# 2004 - 2009 Cadillac XLR XLR-V: Recall Notice: #15643: Special Coverage Adjustment - Airbag Light On

## #15643: Special Coverage Adjustment - Airbag Light On - (Apr 21, 2016)

**Subject:** 15643 — Special Coverage  
Adjustment – Airbag Light On

**Models:** 2004 - 2009 Cadillac XLR  
2005 - 2013 Chevrolet Corvette

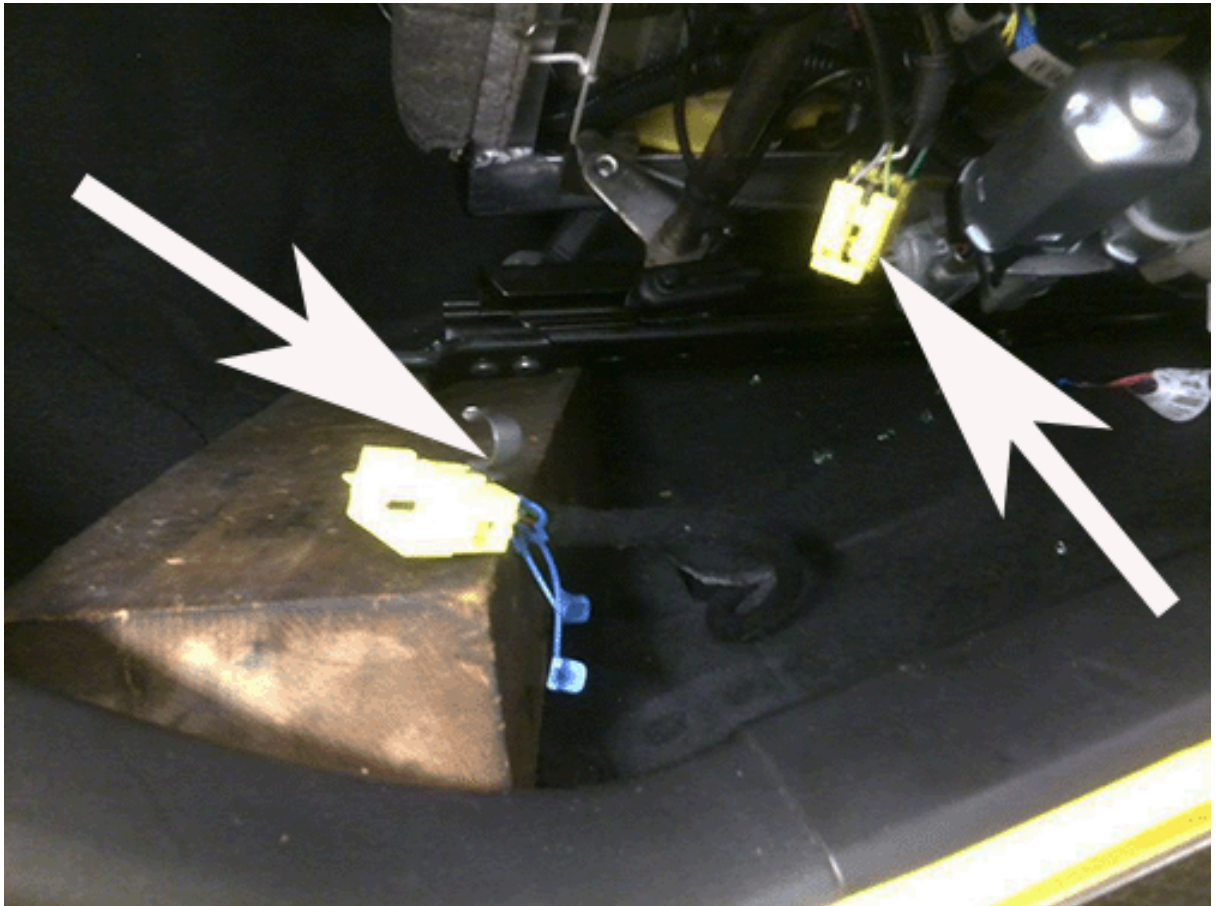
1. Using wood blocks or similar material, tilt and support the seat in the vehicle as shown.

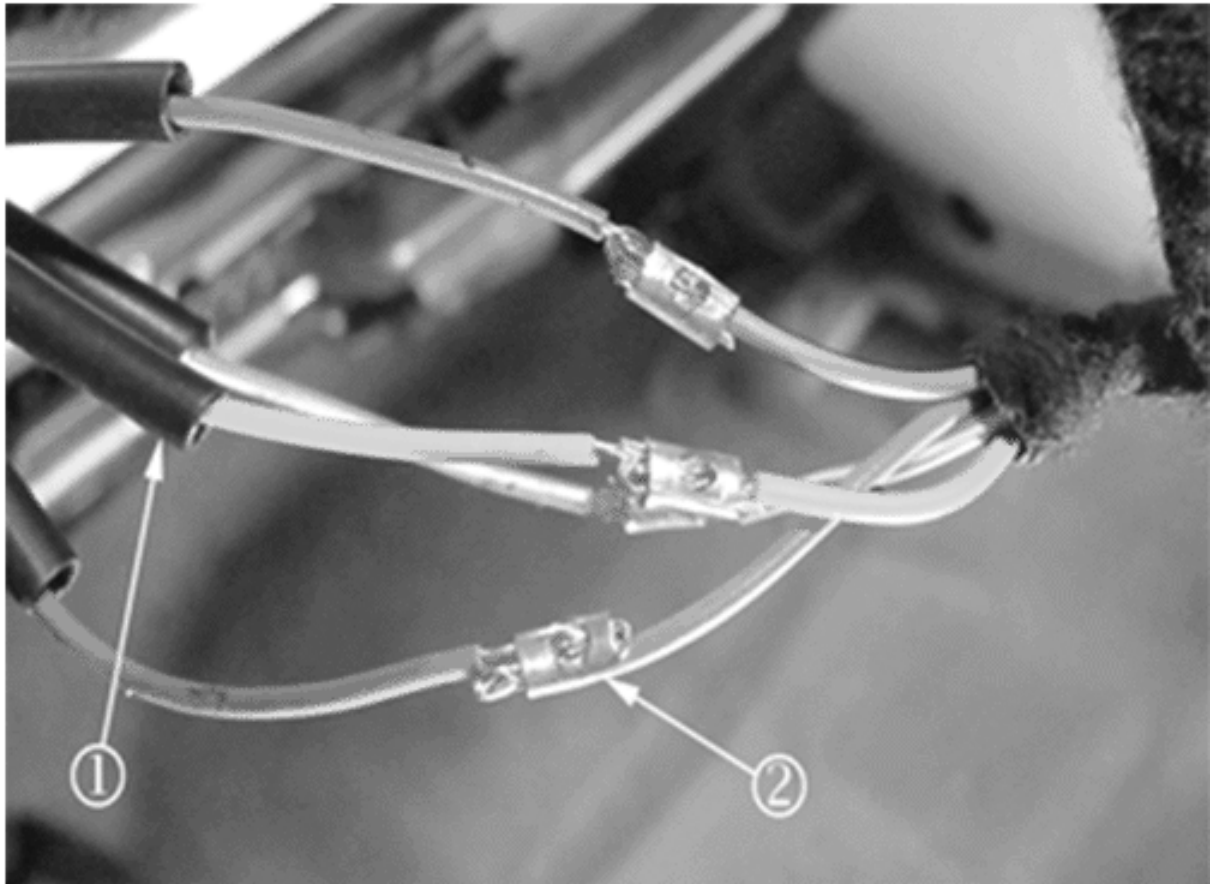
1. Locate the yellow wire connector at the rear cross bar on the seat frame. Remove the connector from the seat cross bar by releasing the metal clip.

**Note:** Before removing the yellow connector from the seat and body harness, note the wire colors of the seat and body harness. Some wire pairs may be a slightly different color. Some wire pairs may have different colors. Ensure the wires are matched **BEFORE** splicing the wires of the seat and body harness together. Use the cutoff connector as a wire color template. **BEFORE** removing the connector from the harness, mark or identify wire pairs of similar color using a pen and tape to ensure the correct wires are spliced together.

1. Make a list of how the wires relate from the body side harness to the seat harness. It critical that the wire pairs

are identified correctly to avoid splicing incorrect wire pairs. *THE WIRE COLORS ON THE BODY SIDE HARNESS AND THE SEAT SIDE HARNESS ARE NOT THE SAME.*

2. Using side cutters, cut the four wires on the body and seat harness as close the connector as possible.

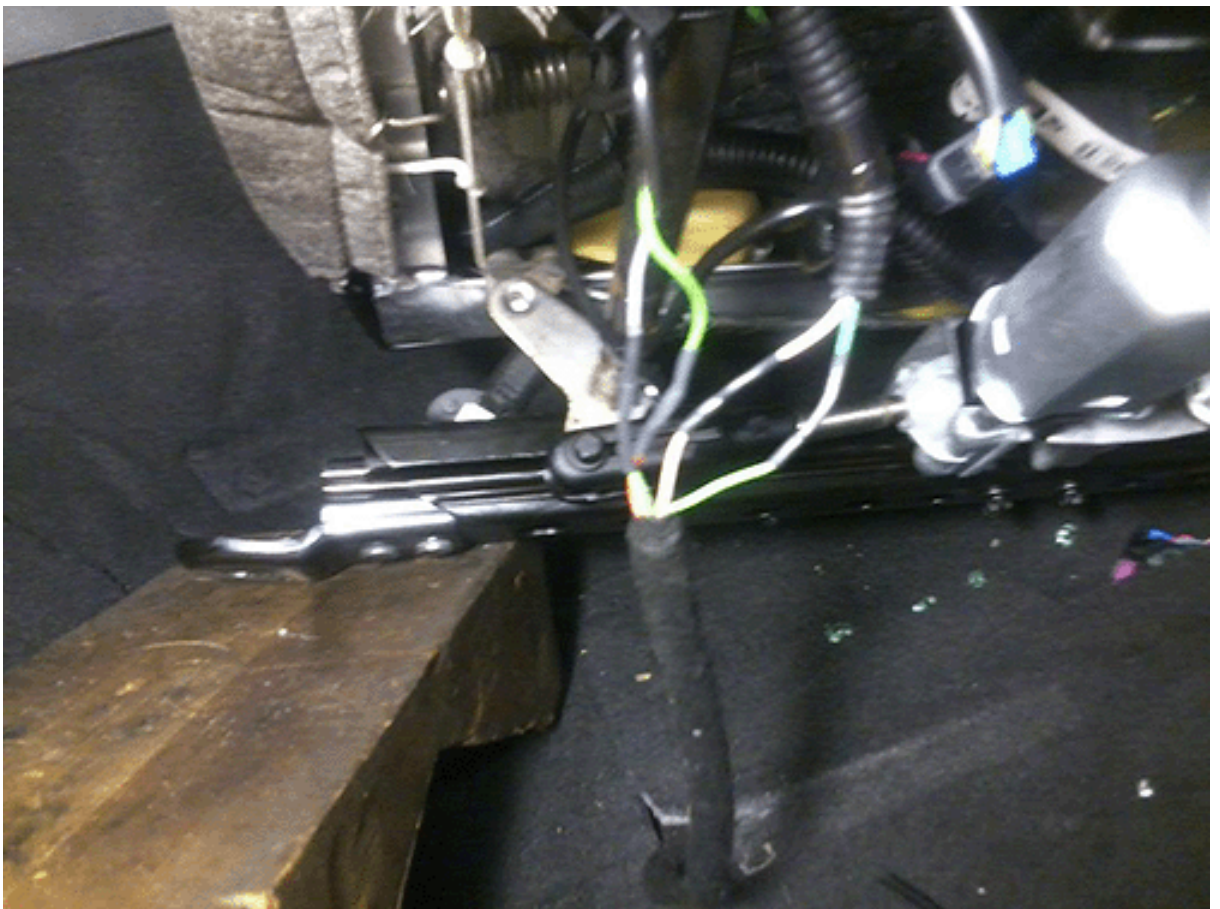
**Note:** Keep the heat shrink tube below the splice when soldering the splice to ensure that the heat shrink is not prematurely shrunk and closed down over the wire or splice area due to the heat from the soldering iron.

1. Solder all four crimp and splice clips using the Ultratorch, part number J-38125-5, or another butane fueled soldering iron.

1. Center the heat shrink tube over all four splices and shrink/seal the heat shrink tube securely over the splice crimp and insulated wires.
